Report: TAB REPORT
Function: Test, Adjust, & Balance
Date: 01/16/2023

**01-09-23 WALGREENS #03606 -
SARASOTA, FL**

Issue Name : EF-5 Not Running

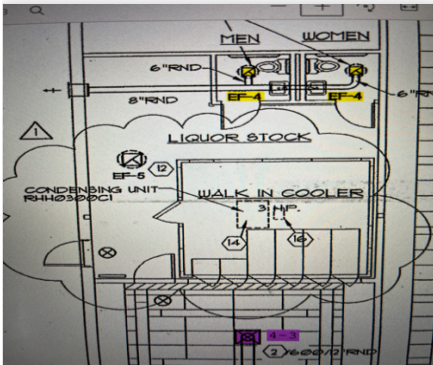
Description : NEW EF-5 (Liquor Stock) is not running. Unable to locate a thermostat or switch to signal the fan. Liquor manager is not aware of any switches nor has he noticed the fan running at any time.

- **02/03/2023** National TAB - Ian Fuller
 - (Resolved) Fan has been replaced and is now running within design.
